# Review of the Shearon Harris Unit 1 Auxiliary Feedwater System Reliability Analysis

Prepared by  
A. Fresco, R. Youngblood, I.A. Papazoglou

Brookhaven National Laboratory

Prepared for  
U.S. Nuclear Regulatory  
Commission

FSAB FIGURE 10.4 DA-2. SHEARON HARRIS NUCLEAR POWER PLANT UNIT 1  
AUXILIARY FEEDWATER SYSTEM AVAILABILITY STUDY FAULT TREE - LOSS OF  
MAIN FEEDWATER (LWFI) AND LOSS OF OFF-SITE POWER (LOOP) CASES  
(SHEET 1 OF 5)

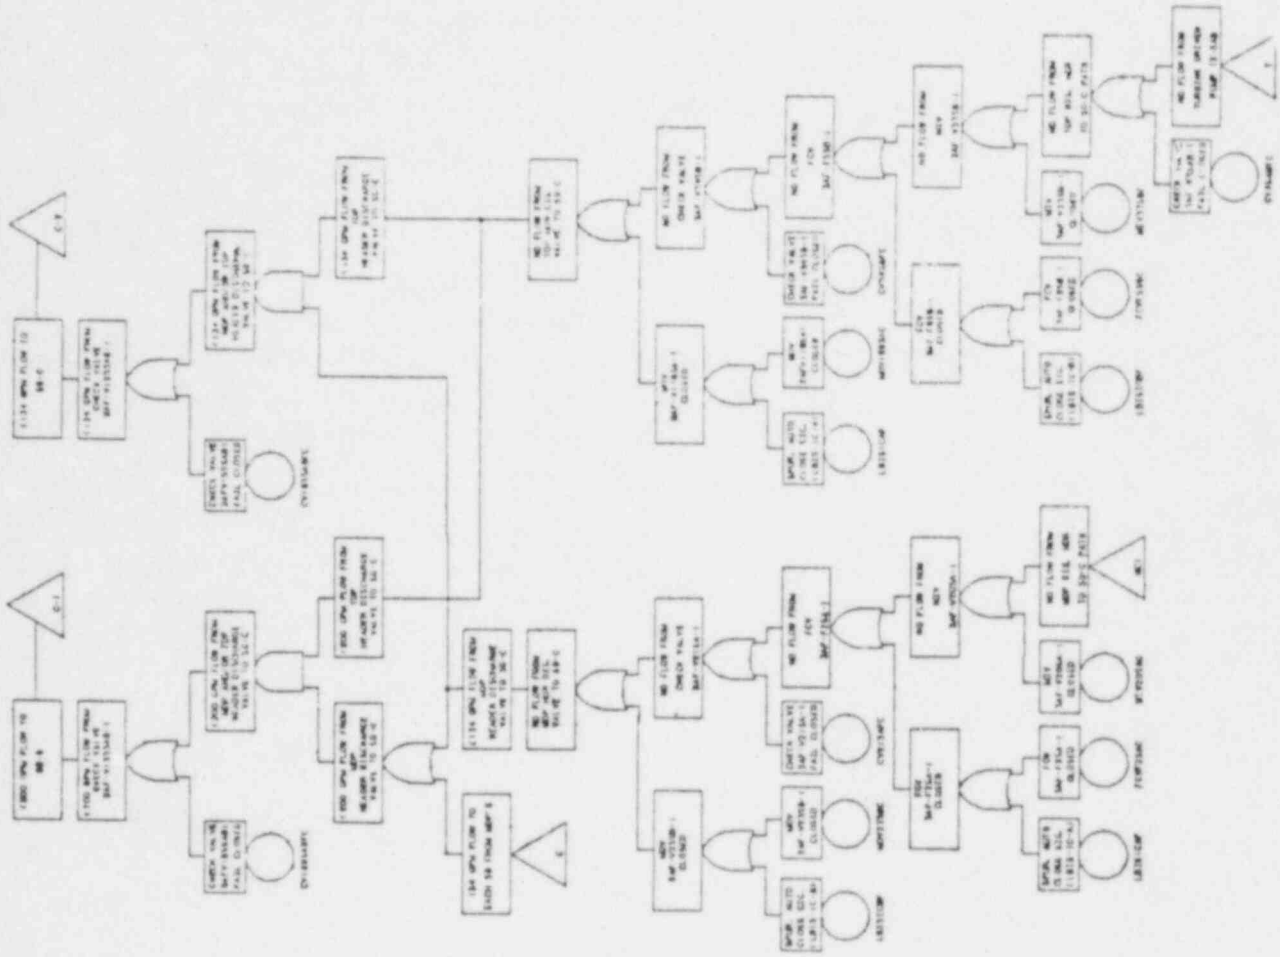
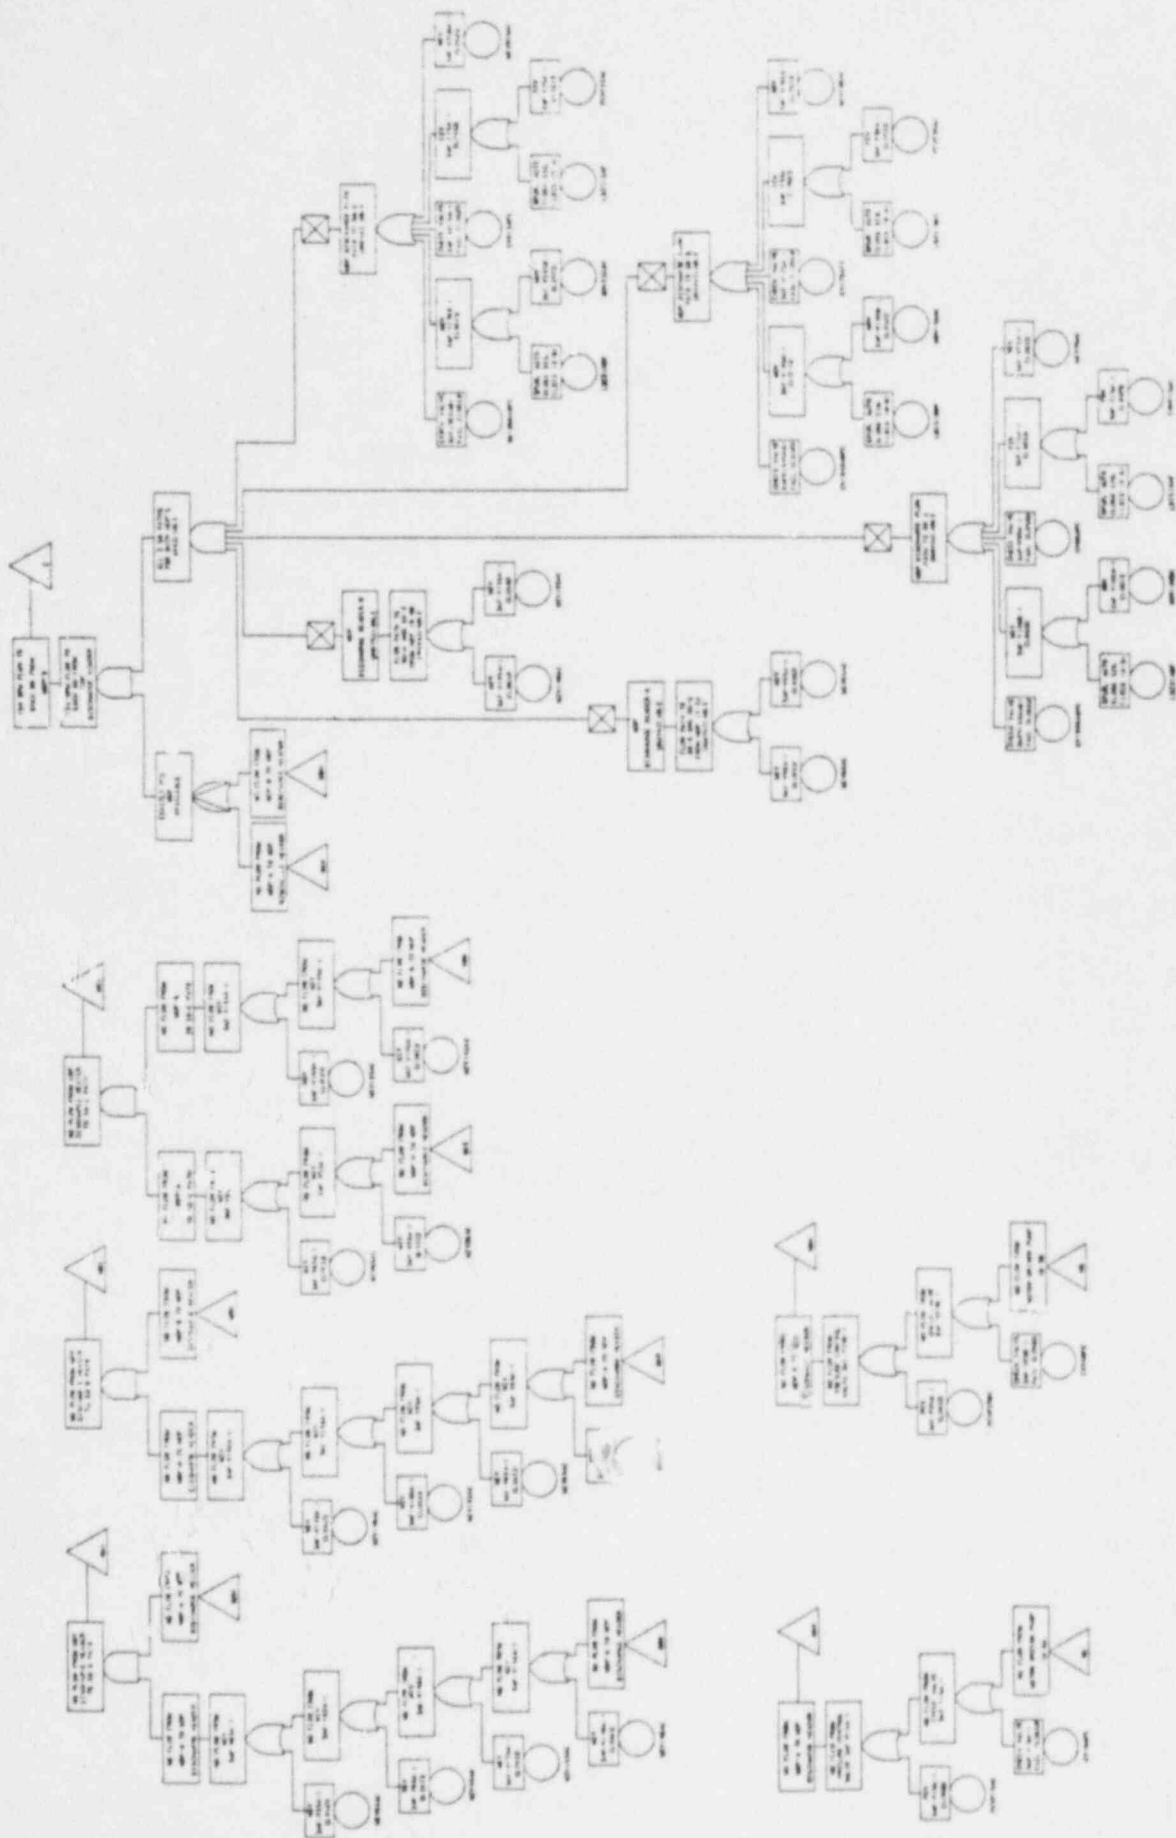
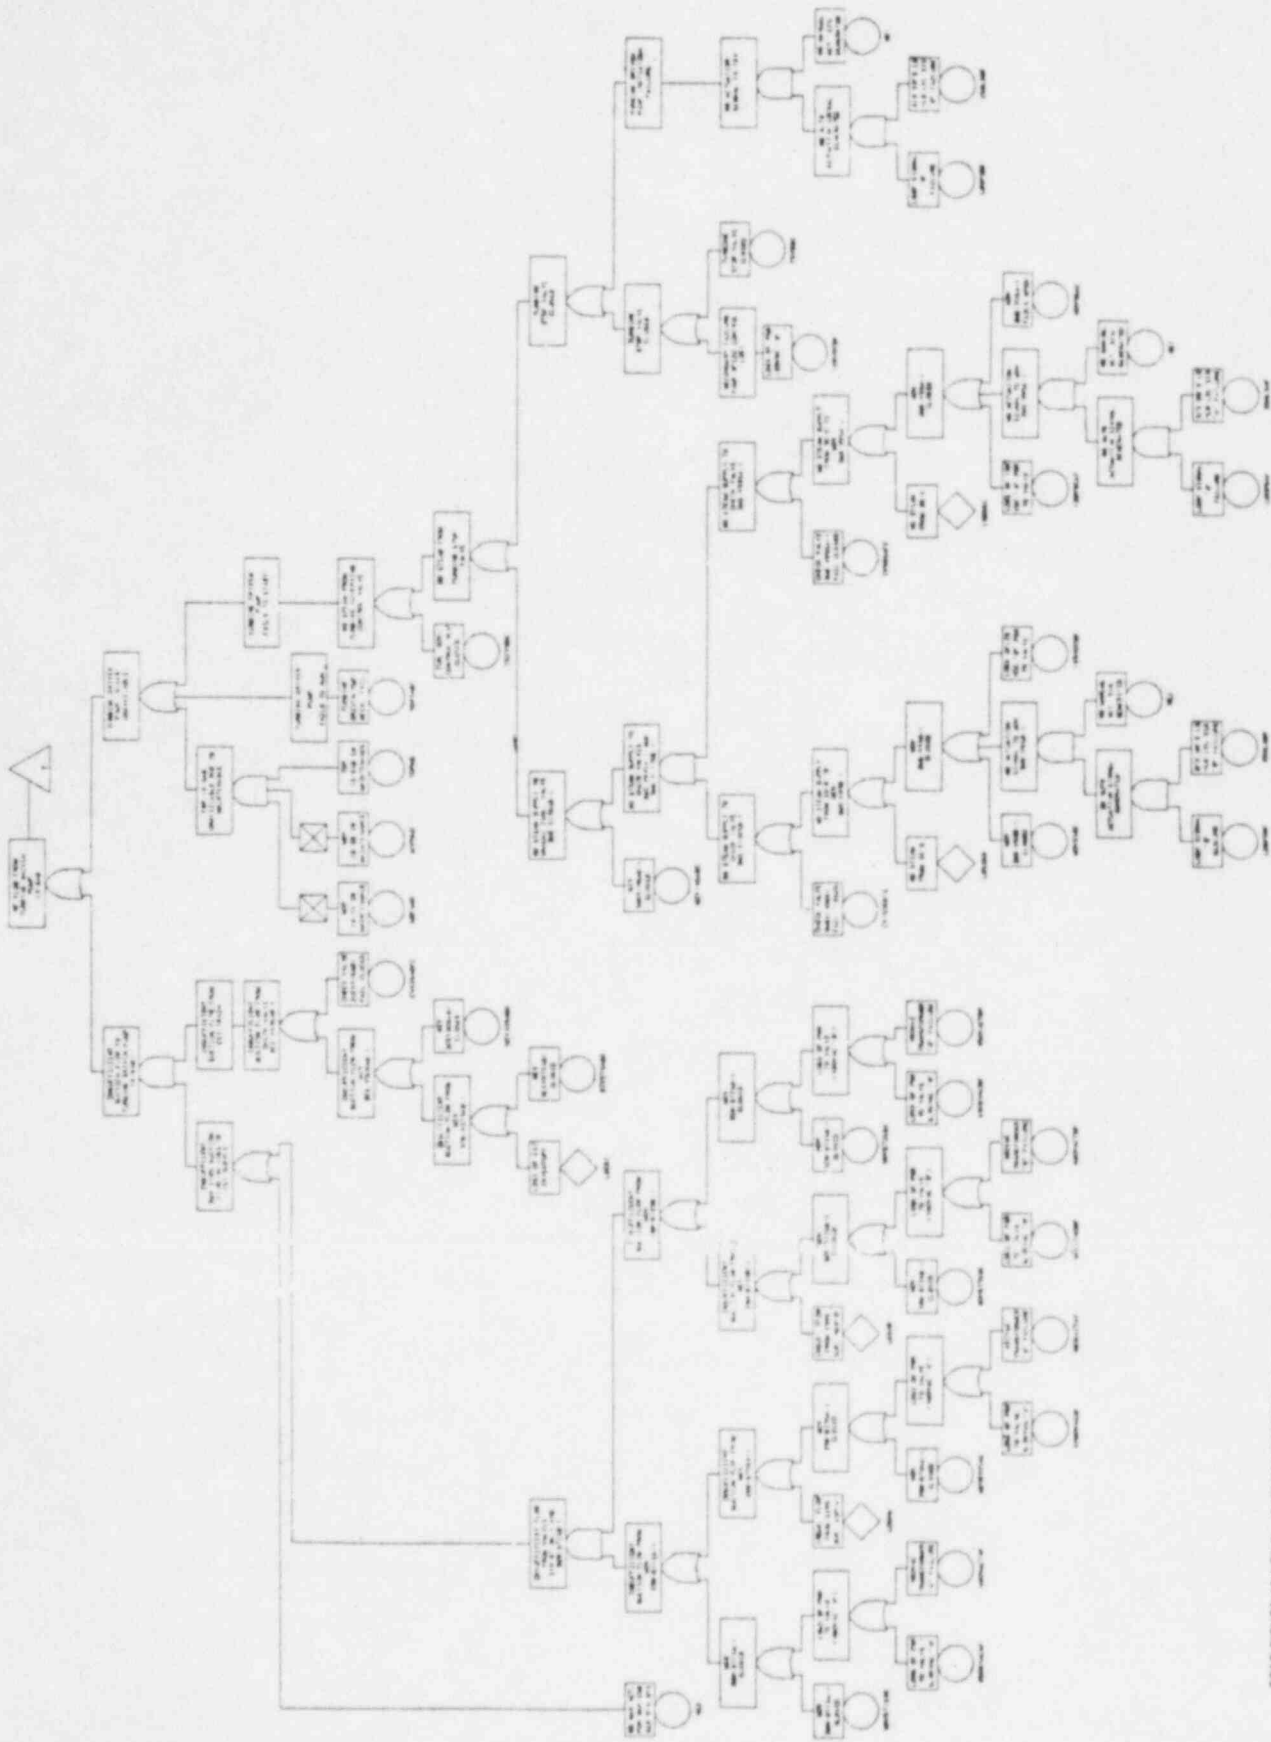
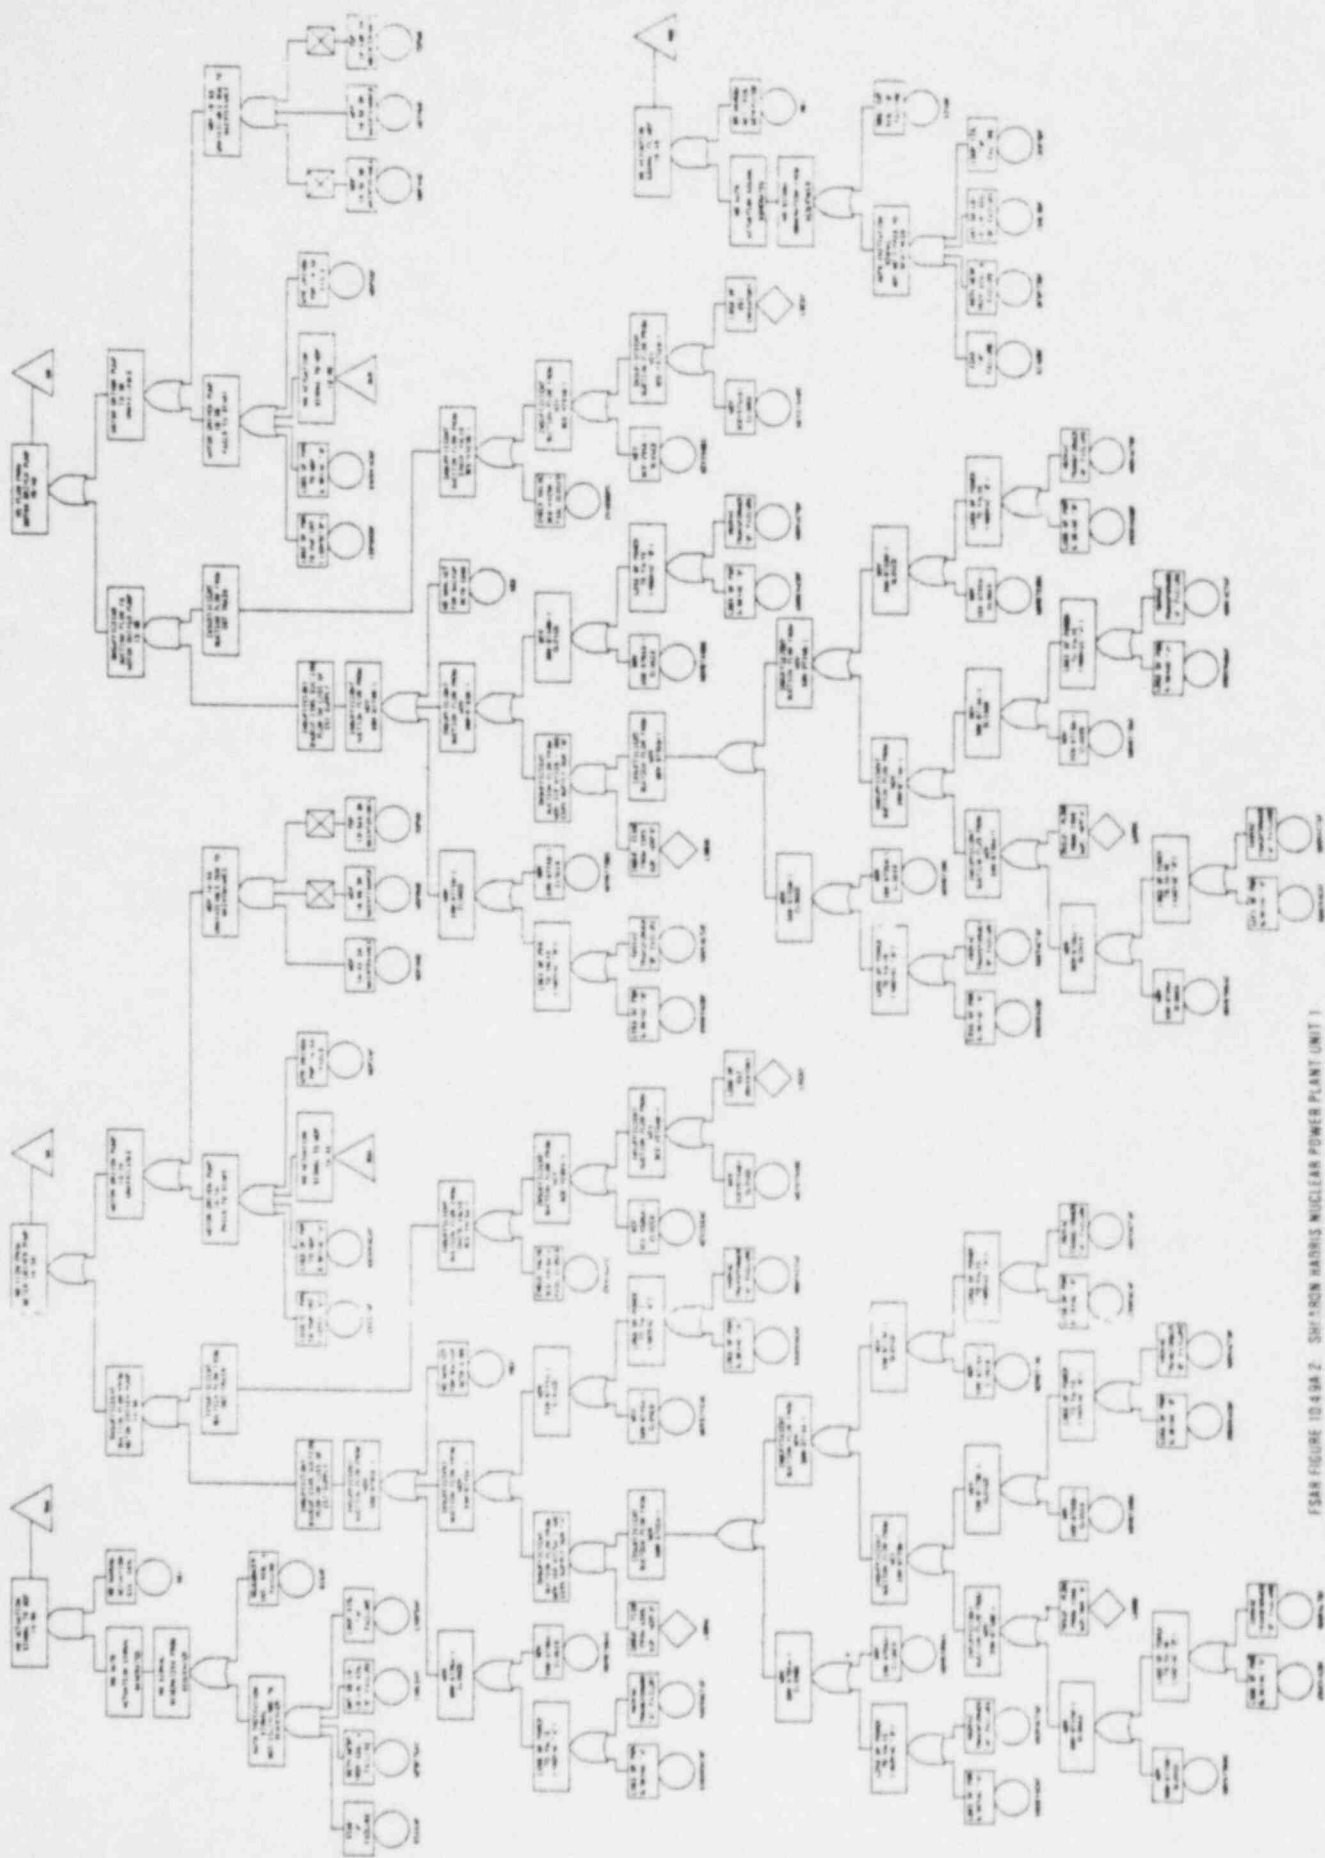
In addition, the applicant's fault trees shown in Figure 10.4.9A-2 of Ref. 3 appear to indicate that only one of the two motor-driven pumps (MDPs) is required for LMFW and LOOP. BNL has assumed that both of the MDPs are required for the LMFW case but only one for the LOOP case.

Figure III-2 of NUREG-0611, "Simplified Fault Tree Logic Structure-LOFW Transient," shows independent failures separately from test and maintenance cut sets. Thus, the applicant's method differs substantially from the NUREG-0611 guidelines. In the BNL analysis, test and maintenance have been identified separately, as explained in Subsection 9.2.3.1 of this report.

This matter is related to the definition of the top event, as explained in Table 10.4.9A-2 of Ref. 3, and the segment of the tree which defines "134 GPM to Each SG from MDPs" and "Exactly One MDP Available." If the applicant has assumed in effect that the flow from two MDPs, or one MDP with its recirculation flow line isolated, is required for mission success in the LMFW case, then the top event required differs from that shown in Figure 10.4.9A-2. The new top event can be created by adding "Failure of the Recirculation Line to be Isolated" as an AND gate with "Exactly One MDP Available."
